10.24.22
Correspondence,
Updated WBD,
FSP analysis

From: Nathan Alleman <nalleman@all-llc.com>
Sent: Monday, October 24, 2022 8:33 AM
To: Rose-Coss, Dylan, EMNRD
Cc: Oliver Seekins; Devin Bowes; Cody Pardue
Subject: [EXTERNAL] RE: Rev Midstream - AABCD SWD #1 & #2 Supplemental Information
Attachments: AABCD SWD #1 WBD 09202022.pdf; AABCD SWD #1 - Revised Injection Interval - Supplemental Information.pdf; AABCD SWD #2 WBD 09202022.pdf; AABCD SWD #2 - Revised Injection Interval - Supplemental Information.pdf; REV Midstream - AABCD FSPs.pdf

I've completed the technical review of the Rev Midstream SWD #1 application for the AABCD SWD No. 1 (SWD-2399; pBL2030733650) and the AABCD SWD No. 2 (SWD-2400; pBL2030734512) wells. To move forward with the reviews I will need a few items and points of clarification from Rev Midstream, namely:

AAABCD SWD #2
Wellbore Diagram
2416' FWL & 788' FSL S-31 T-21S R-28E
Lat: 32.431558° Long: -104.126617°
Eddy County, New Mexico

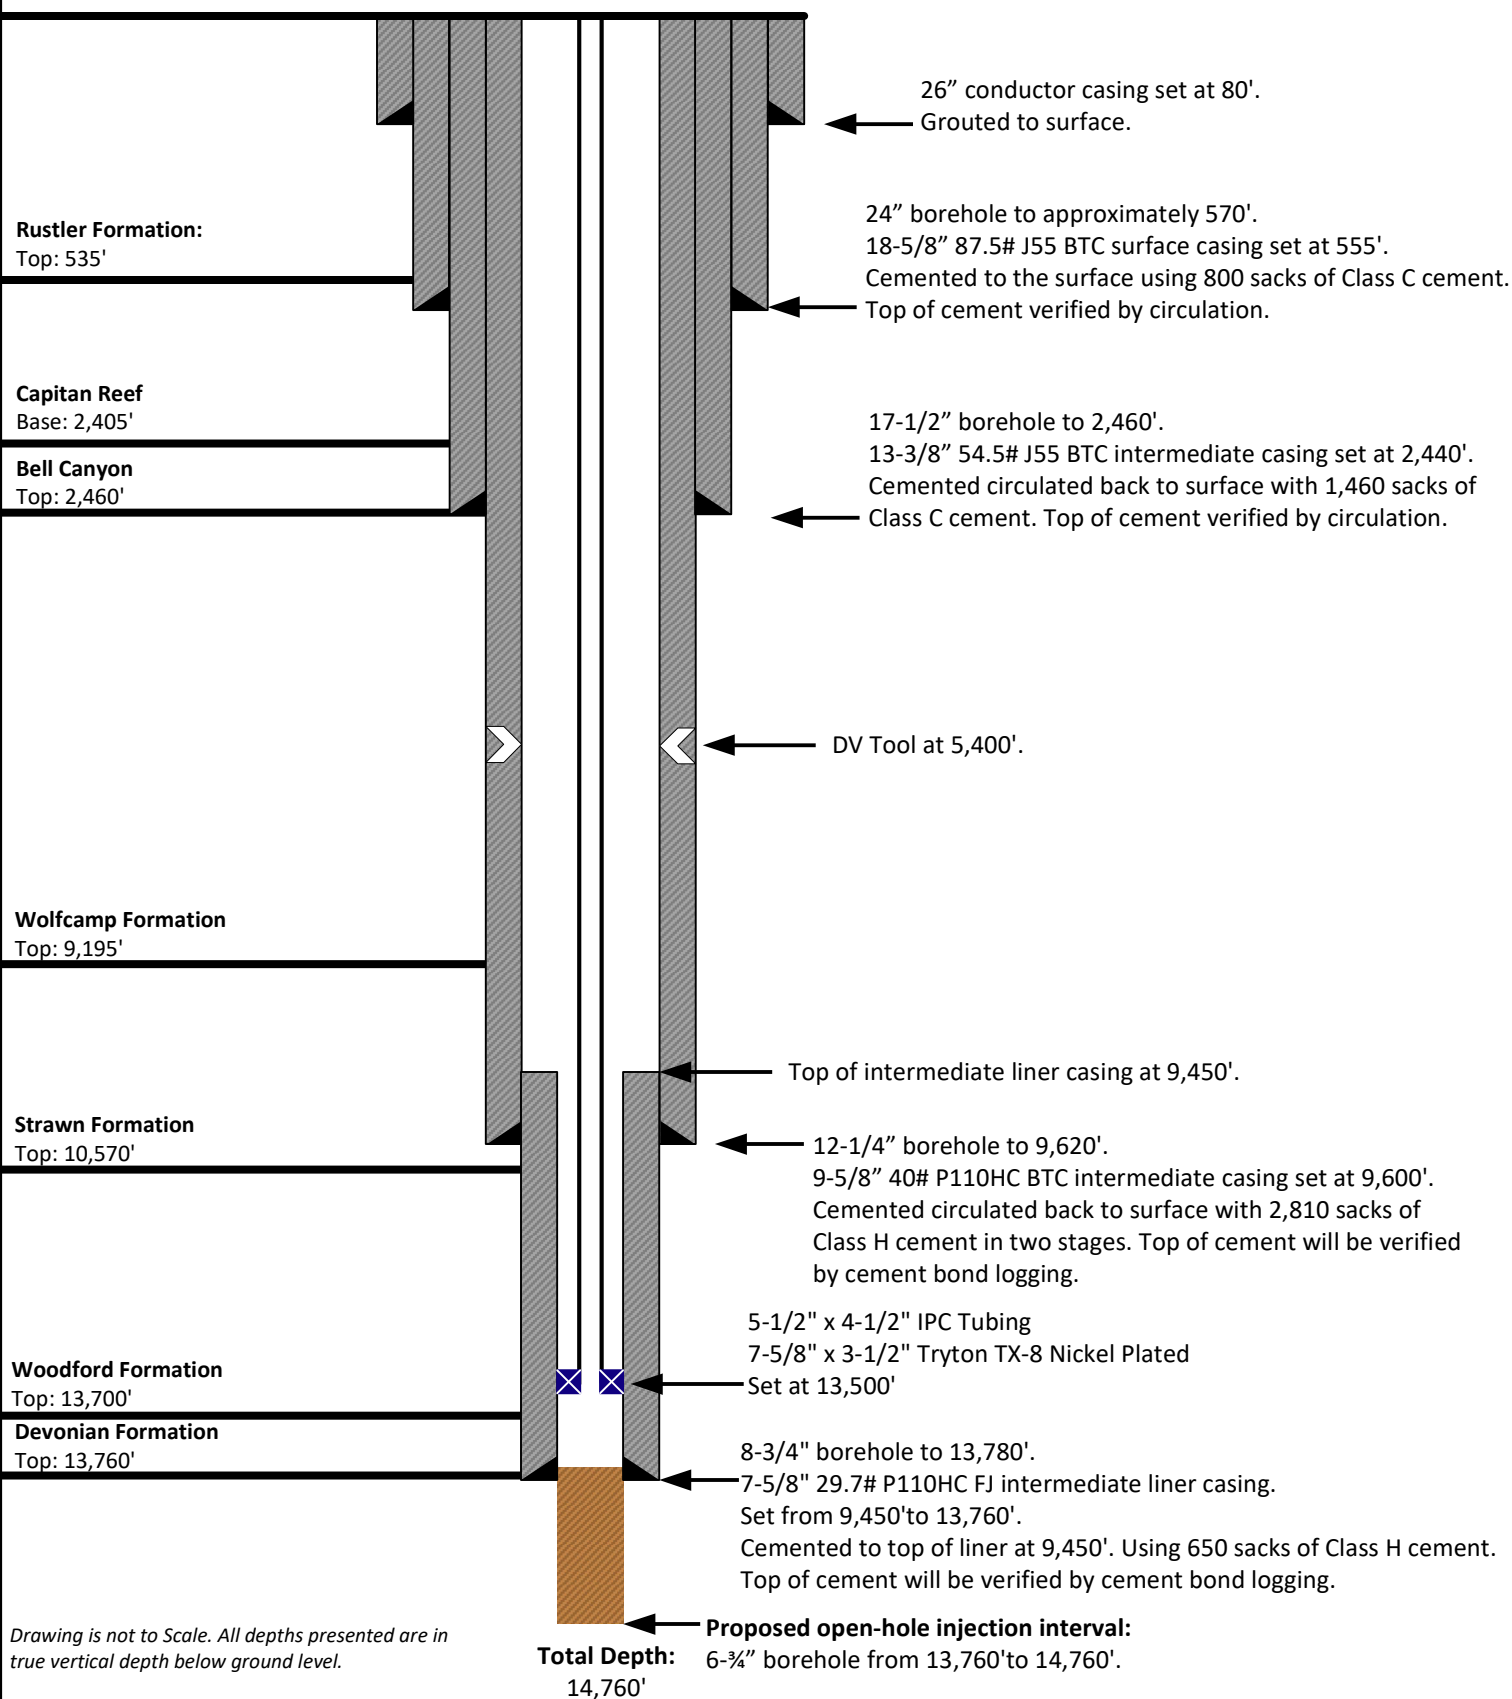
1. [OCD Request: Please confirm the method of determining the top cement for the 7" production casing string. The injection well data sheet indicates that the cement will be circulated to the surface, but the wellbore diagram suggests that the top will be at 9500'. The OCD requests that the 7" production string tie in 200' above the intermediate casing.](#)

- **Response:** The well design has been updated to clarify cement tops and methods of determination (see attached Supplemental Information and Wellbore Diagrams). Additionally, the well designs were updated to reflect corrected depths for the Devonian Injection Interval. Wellbore Diagrams and Well Data Sheets reflecting the updated well designs are attached.

AABCD #1 FSP Area Map

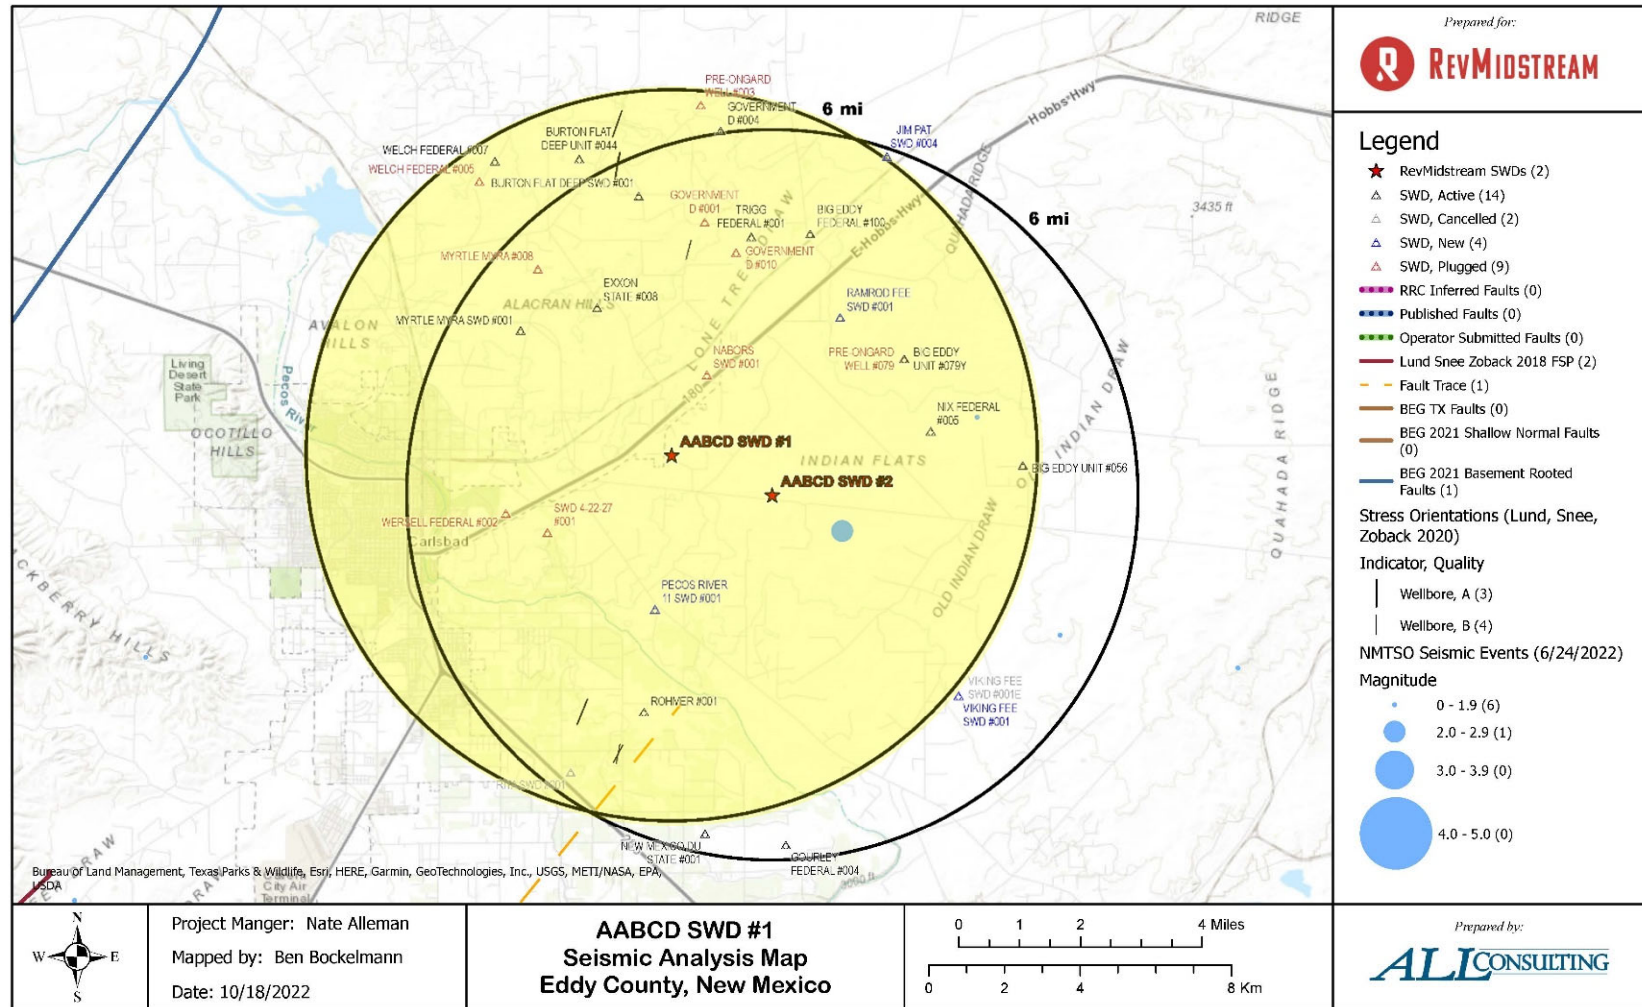
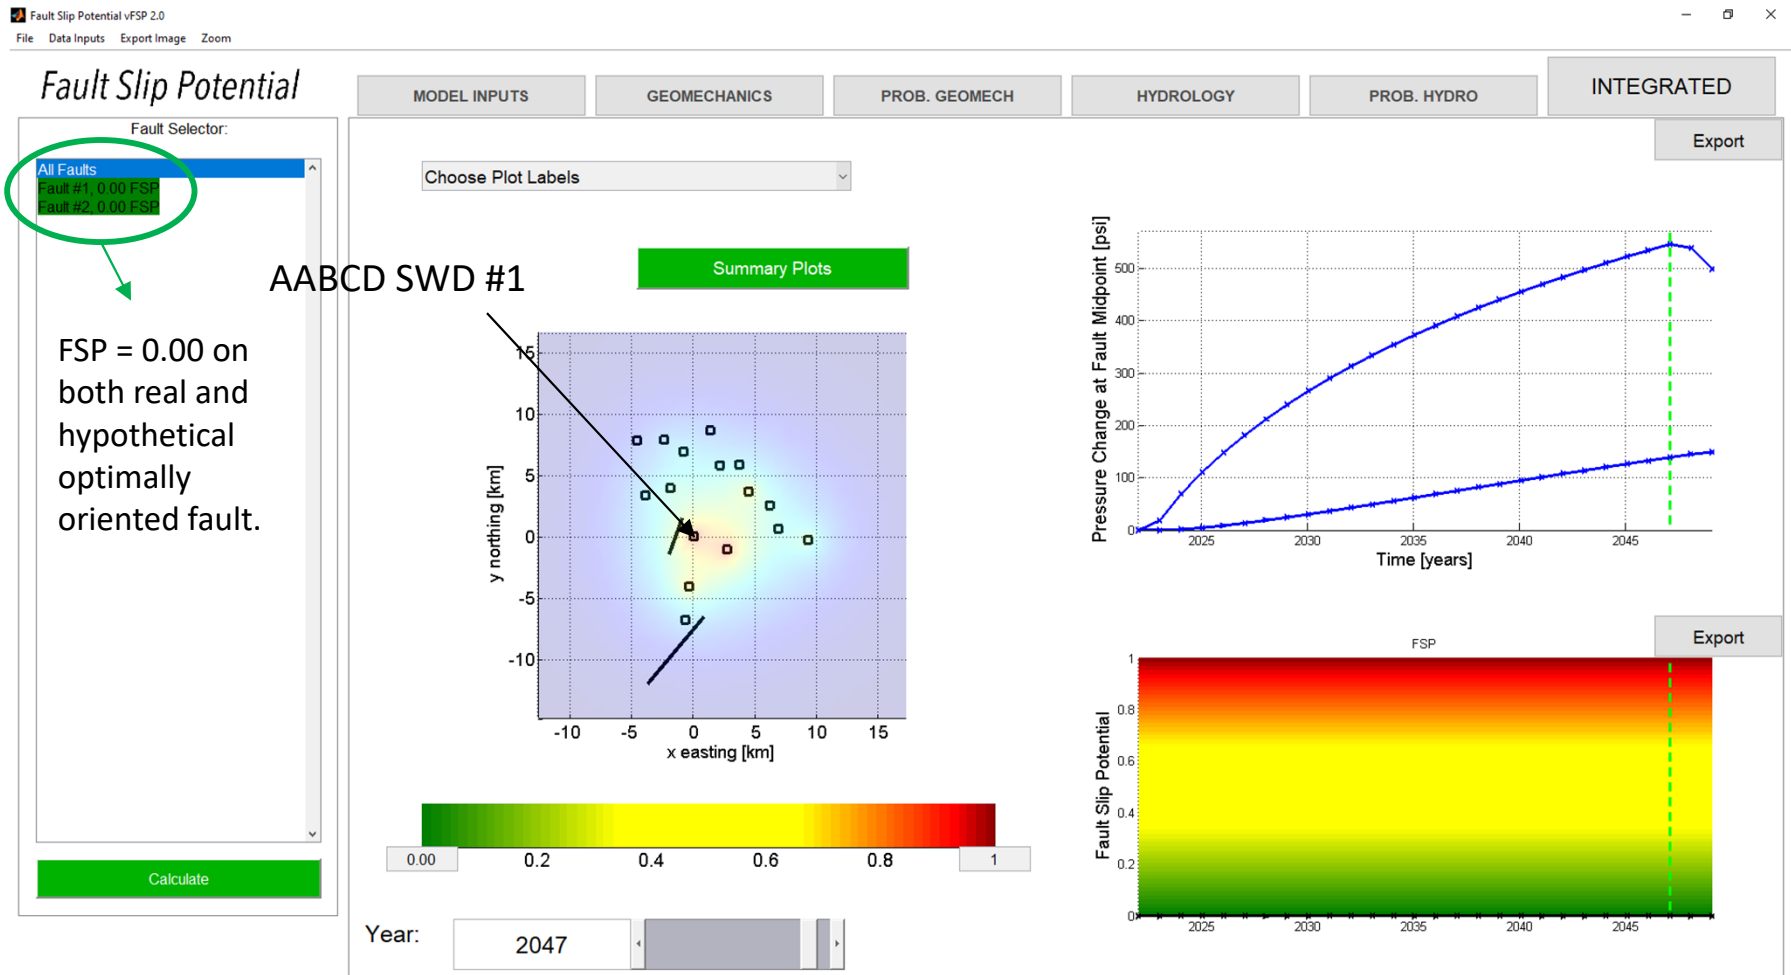
3. [OCD Request: Submit a fault slip potential \(FSP\) model to supplement the induced seismicity analysis.](#)
 - a. [I would refer you to case no 20964 re: Overflow Energy's Rita SWD # 1 application. In the case files nearby fault traces are identified that should be incorporated into the model.](#)

- b. [Include a model run scenario that incorporates a fault trace within one \(1\) mile of the proposed well that is optimally oriented to slip.](#)
 - **Response:** FSP models were run for the AABCD SWD #1 and #2 using the criteria specified above and the models resulted in a 0.00 FSP value on both the known and hypothetical faults.
